METROPOLITAN GOVERNMENT OF NASHVILLE AND DAVIDSON COUNTY

STAFF RECOMMENDATION 1801 Woodland Street December 17, 2014

Application: Violation
District: Lockeland Springs-East End Neighborhood Conservation Zoning Overlay
Council District: 06
Map and Parcel Number: 08310030800
Applicant: Cathedral Homes
Project Lead: Robin Zeigler robin.zeigler@nashville.gov

FIRST FLOOR PLAN

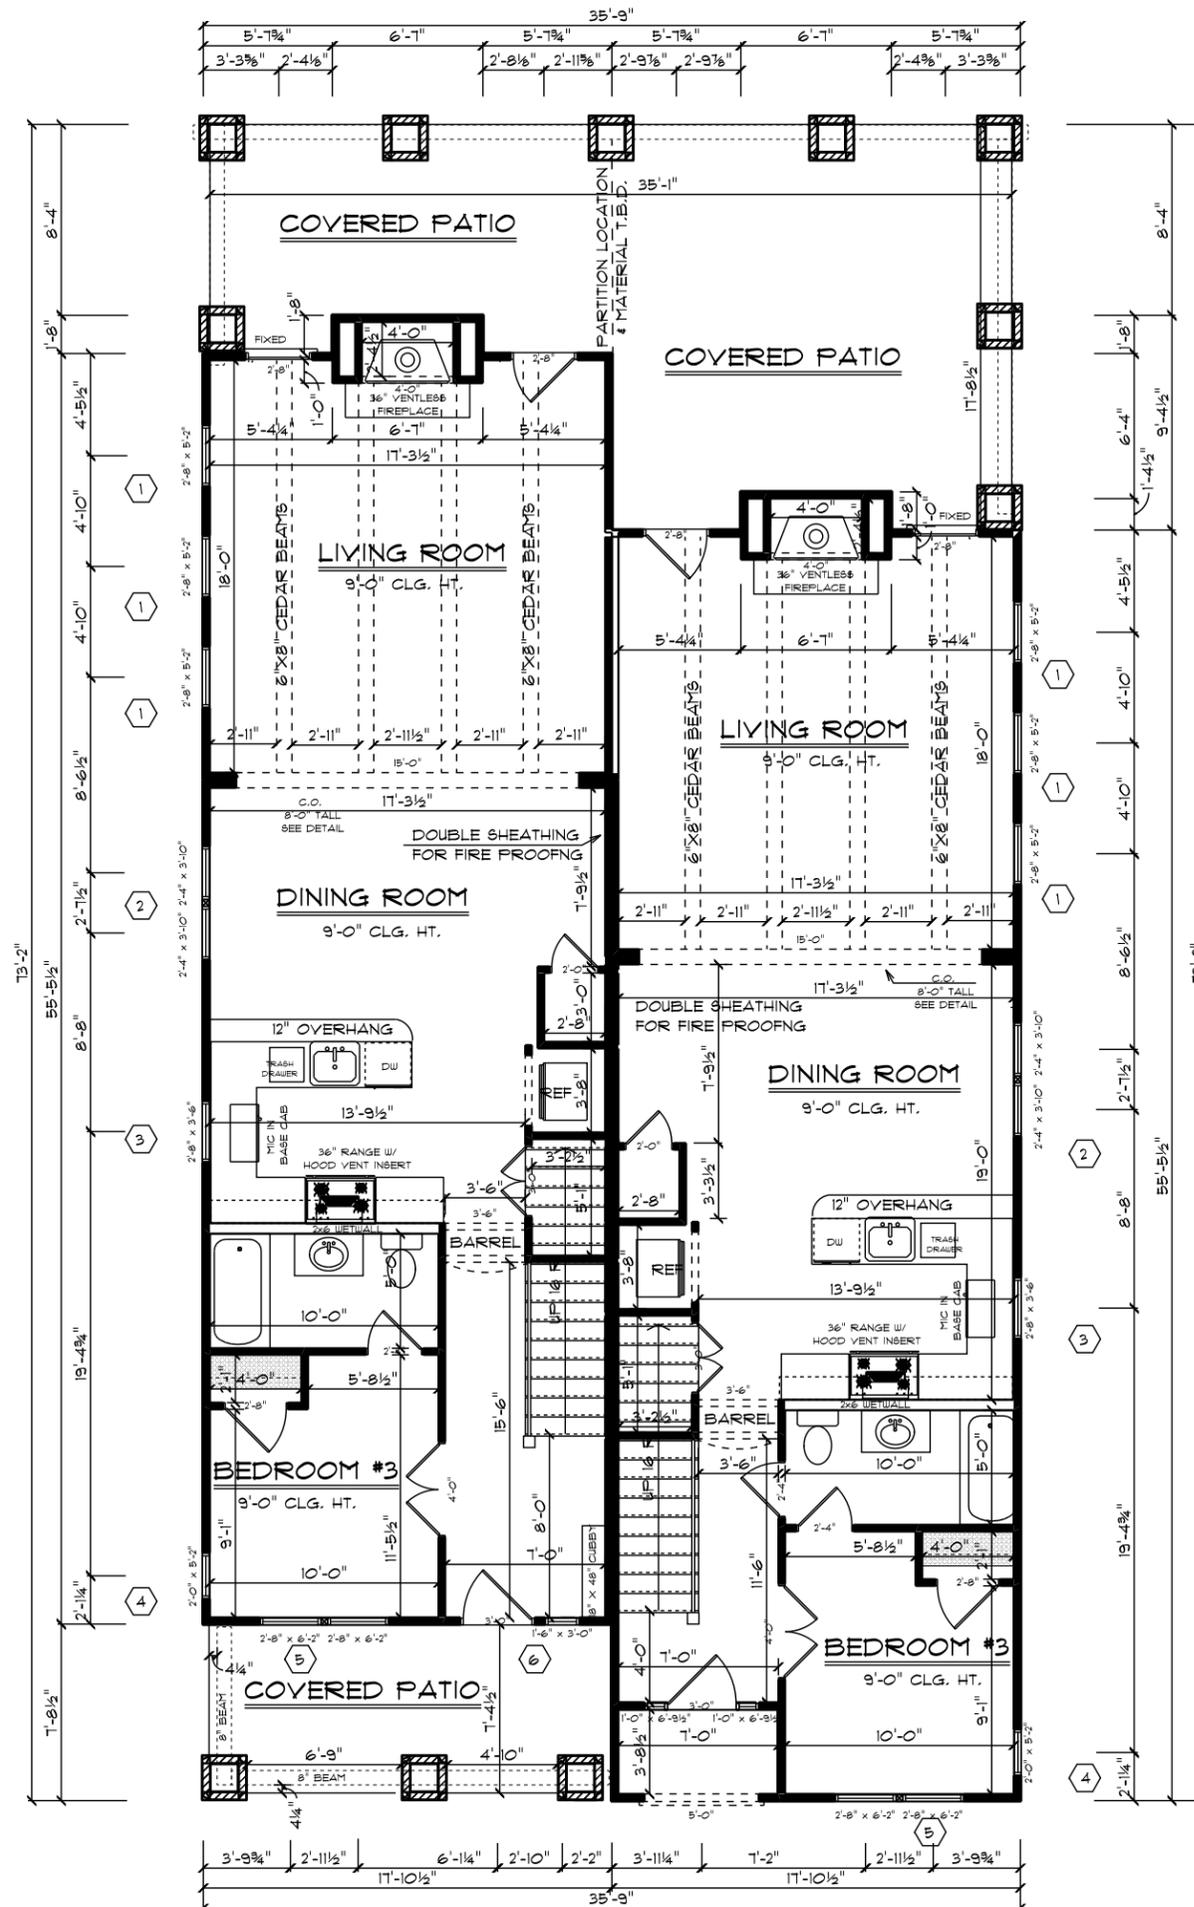
Analysis and Findings: Applicant is requesting alterations to the previously approved width of the duplex from thirty-five feet (35') to thirty-six feet five inches (36' 5"); to the left-side setback from ten feet (10') to eight feet and nine inches (8' 9"); to the right side setback from five feet (5') to four feet four inches (4' 4") towards the rear; and to the previously proposed window openings. The foundation is in place. Our inspecot identified that the width was incorrect when the foundation footers were poured. At that time, MHZC Staff required a correction of the footers and the left (west) section was removed and re-poured, incorrectly, a second time. The block foundation was then erected before MHZC Staff could again stop the project.

The setback determinations now requested are different than bulk zoning requirements. The setbacks are further exacerbated by the fact that the brick veneer of the foundation will now extend beyond the side-wall rather than being flush with the wall as originally proposed and is typical for historic buildings. The left side (18th Street) setback should be ten feet (10'), but the house, once the brick veneer is added will be eight feet and five inches (8' 5") from the left side property line. Because the house is slightly skewed it will gradually become closer to the appropriate left-side setback but never quite meet it. The right rear corner of the house, once the brick veneer is added, will be four feet and four inches (4' 4") from the right property line, rather than the five required by bulk standards. This encroachment affects approximately four-feet of the rear of the building.

Because the Commission initially found that a left-side setback to be inappropriate and did not meet the design guidelines for setbacks, the policy for setback determinations, or the rhythm of the street, Staff recommends disapproval of the currently proposed left setback.

Because the encroachment into the right-side setback is minimal and does not include the entire right side of the house, Staff recommends approval if the right-side property owner does not oppose the encroachment.

Recommendation Summary: Staff recommends disapproval of the proposed left setback, the width of the house and the addition of horizontal windows, finding that the revised proposal does not meet the design guidelines for rhythm of the street, scale, setbacks and window proportions.

Staff recommends approval of the right-side setback because of its minimal encroachment into the setback area, if the right-side property owner does not oppose the encroachment.

Sheet **A5**

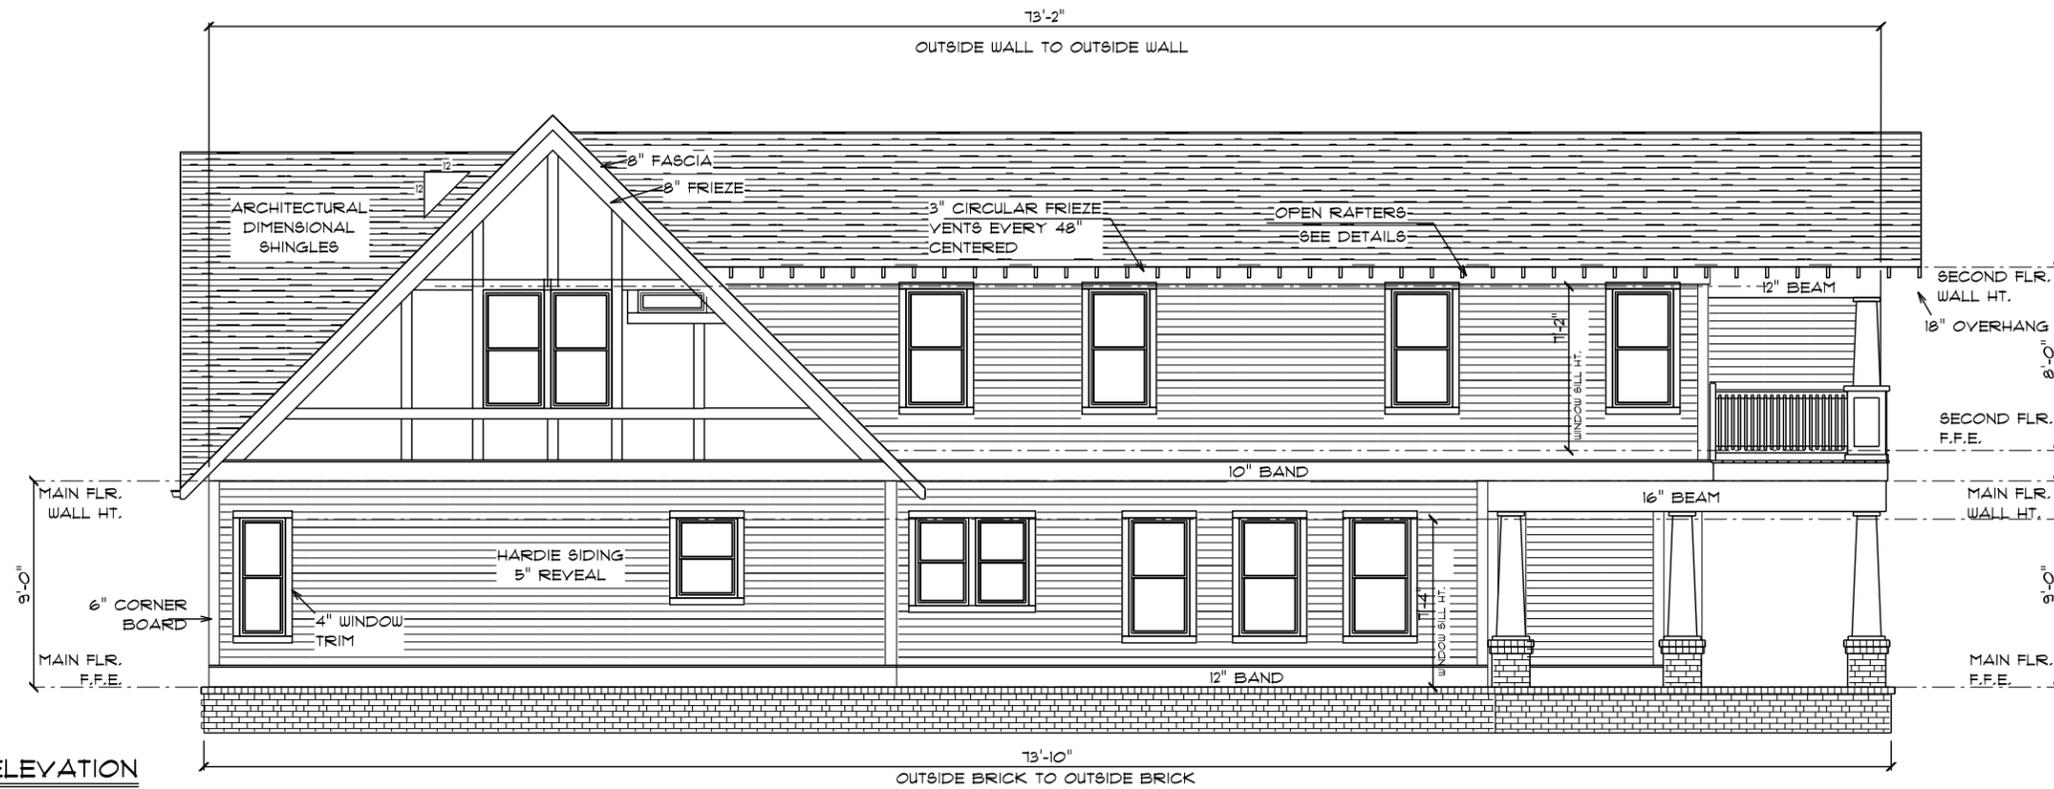
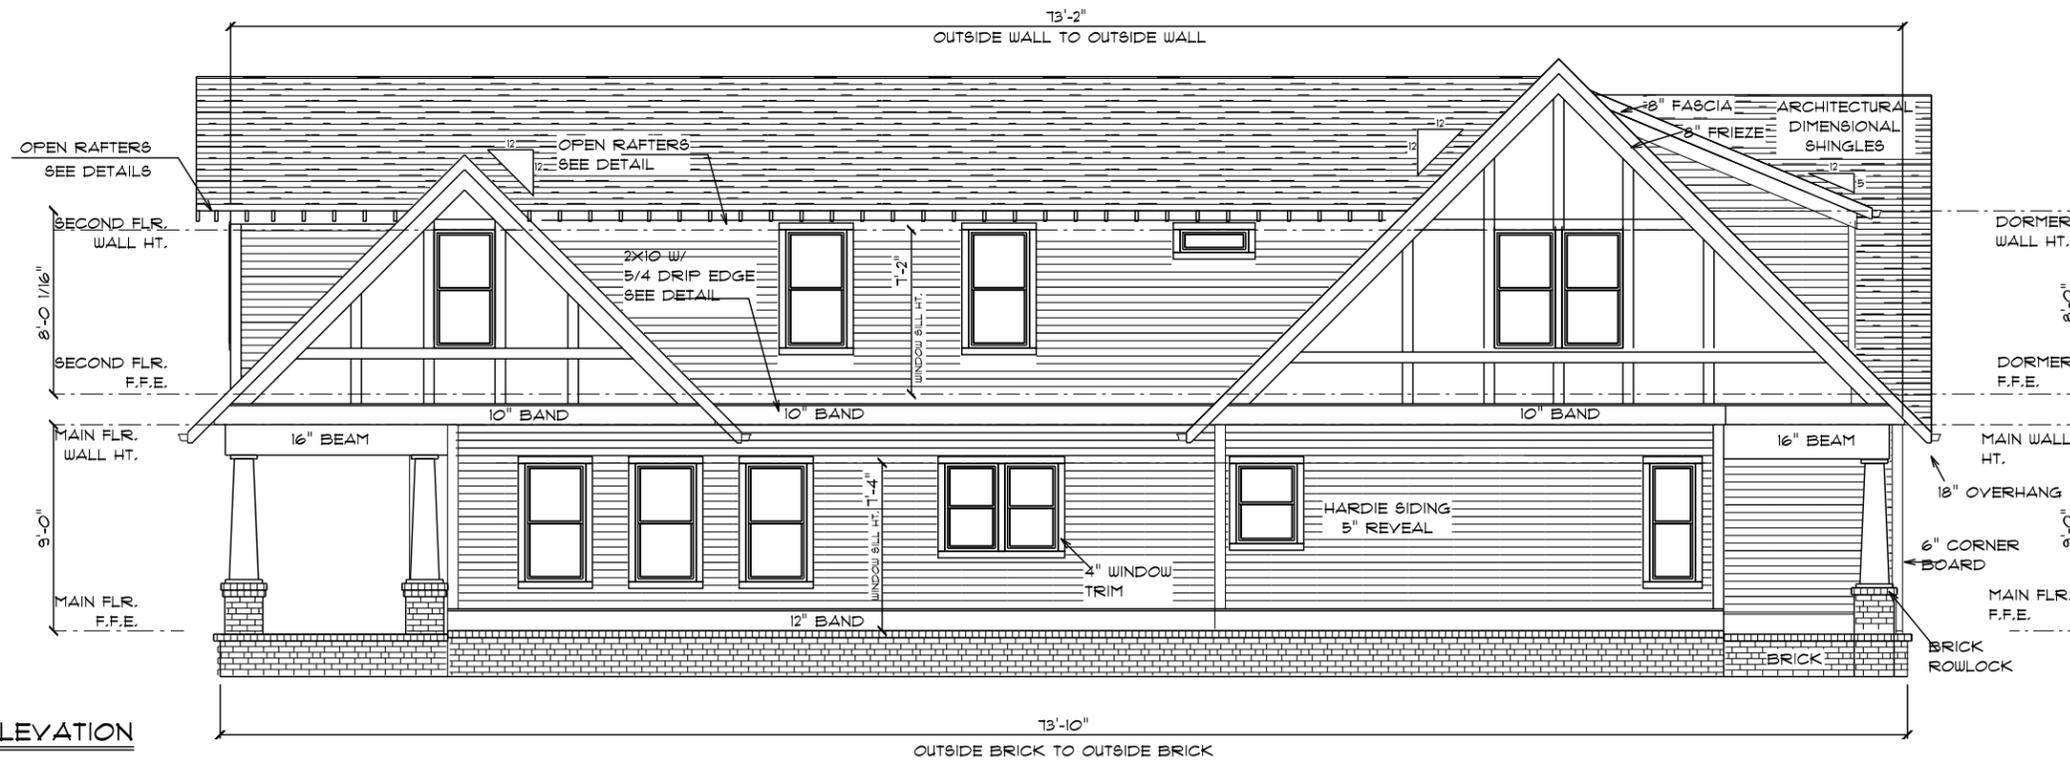
Two horizontal windows have been added to both side elevations. Staff recommends disapproval of these windows as they do not meet the design guidelines for appropriate window proportions.

There are two windows missing on the side elevations. The second windows from the front, on both sides, have been removed in the revised proposal. These changes create unbroken walls of more than fifteen feet (15') and therefore do not meet the design guidelines for rhythm of openings.

FRONT ELEVATION

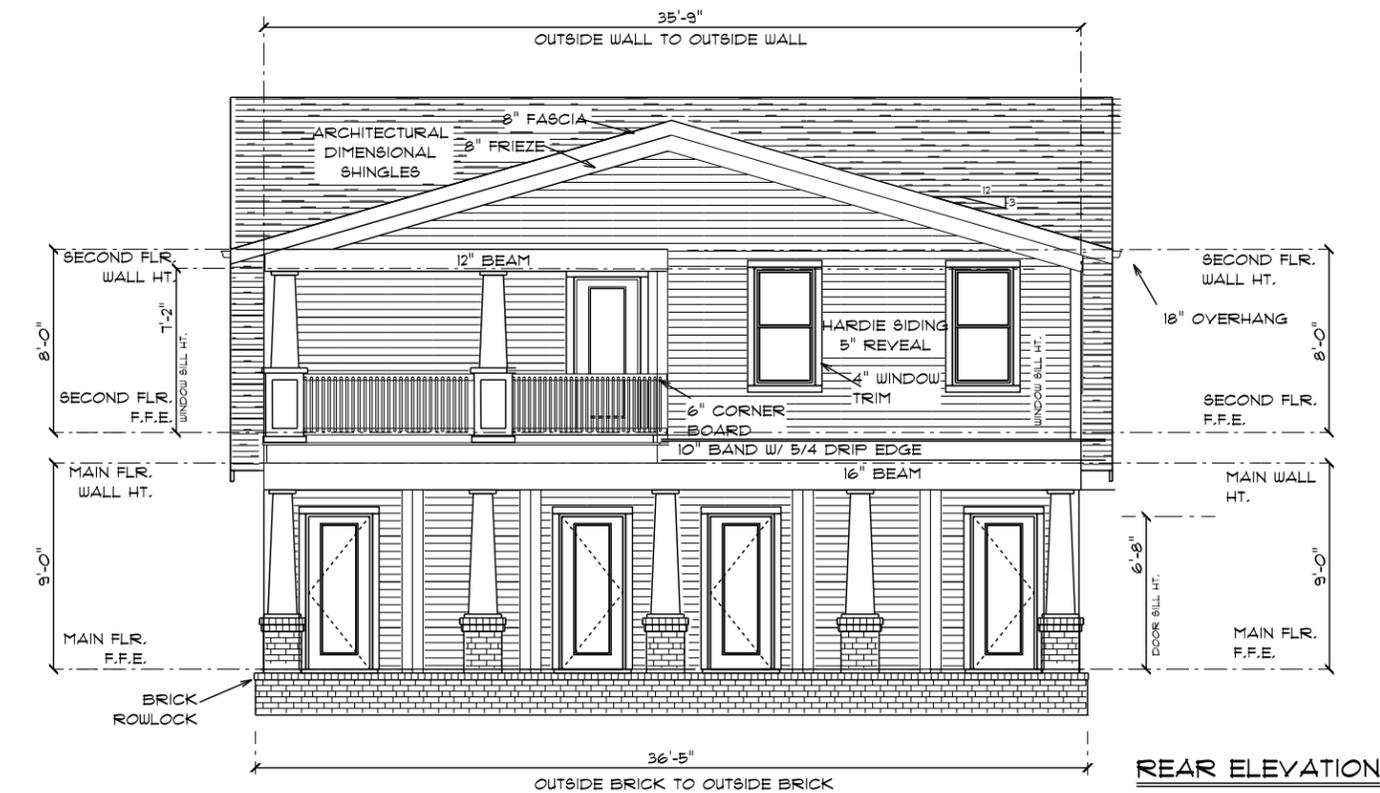
Proportion and Rhythm of Openings: There are some alterations to the window openings. The paired windows in the front gable field initially had a four inch to six inch (4"-6") mullion between the two windows. The Commission typically requires this of paired windows as it matches historic conditions; therefore, staff recommends that the mullion be retained which will mean that the windows will need to be smaller or moved down on the wall. Staff recommends administrative review of a new front elevation.

Staff recommends approval of the alteration of the paired windows in the front gable-field with the condition that staff provides an administrative review of a new front elevation showing a four inch to six inch (4" to 6") mullion between the windows.
